GFA AIRWORTHINESS DIRECTIVE

- TYPE AFFECTED:** AMT 200 Super Ximango.
- SUBJECT:** Electric system - Inspection of Stator and Ignition Cables of Rotax Engines 912 A2.
- BACKGROUND:** Due to an unfavourable influence of some chemical reactions, improper installation or maintenance, the insulation material of the stator cables of the alternator could be damaged which might lead to problems with the ignition.

ALERT SERVICE BULLETIN

Title: ELECTRIC SYSTEM – INSPECTION OF STATOR AND IGNITION CABLES OF ROTAX ENGINES 912 A2

Figure 1

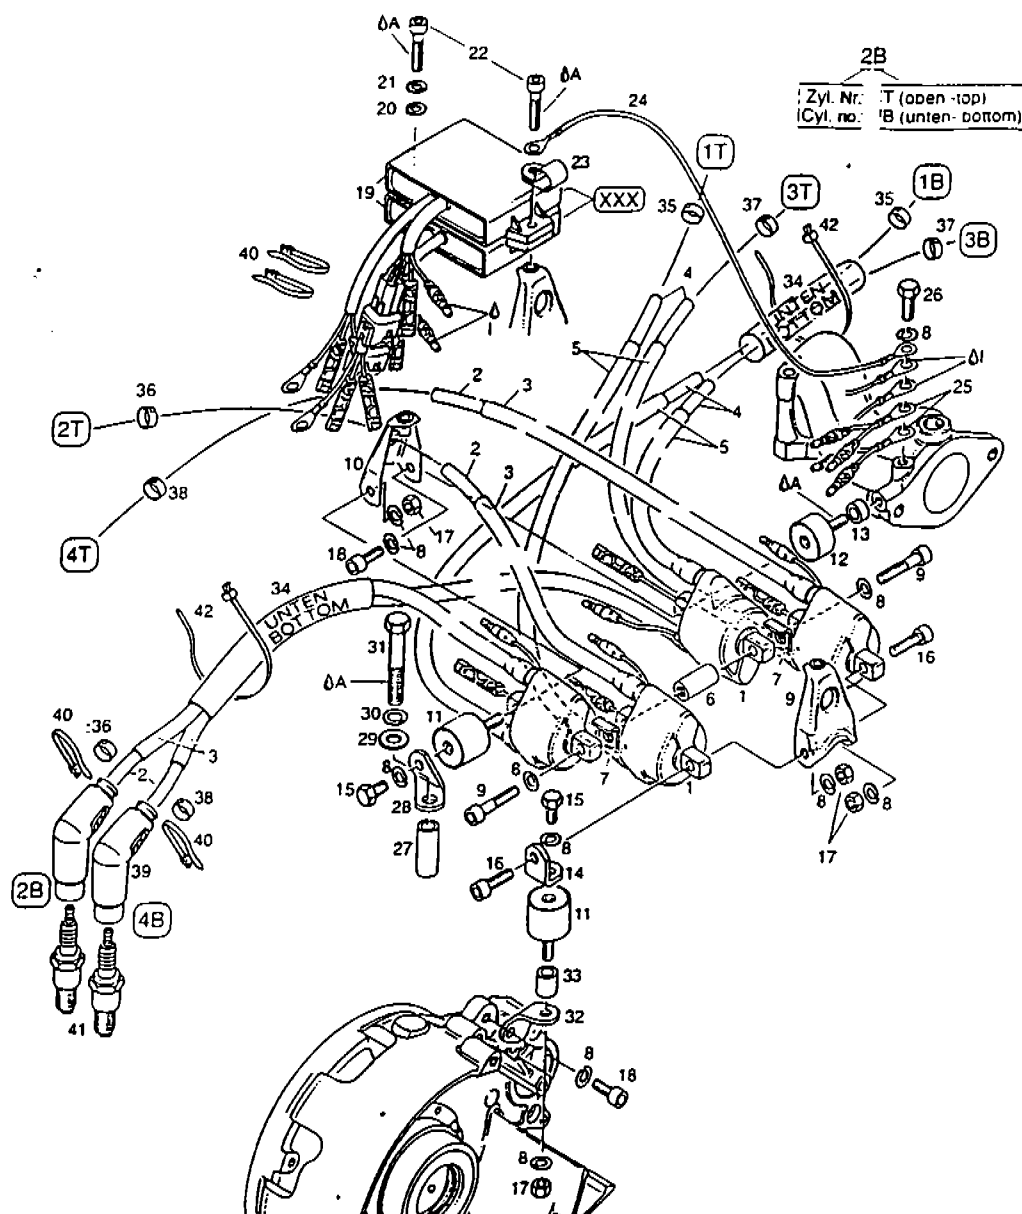
- 2.1** Check the ignition unit for mechanical, thermal and chemical damages (See figures 1 and 2).
- 2.2** Check all cable connections, all ground connections, charging and shorting cables and grounding cables for tight fit, good contact, corrosion and safety; repair as necessary.
- 2.3** Verify shielding of cable assemblies for damage, for grounding contact and safety.
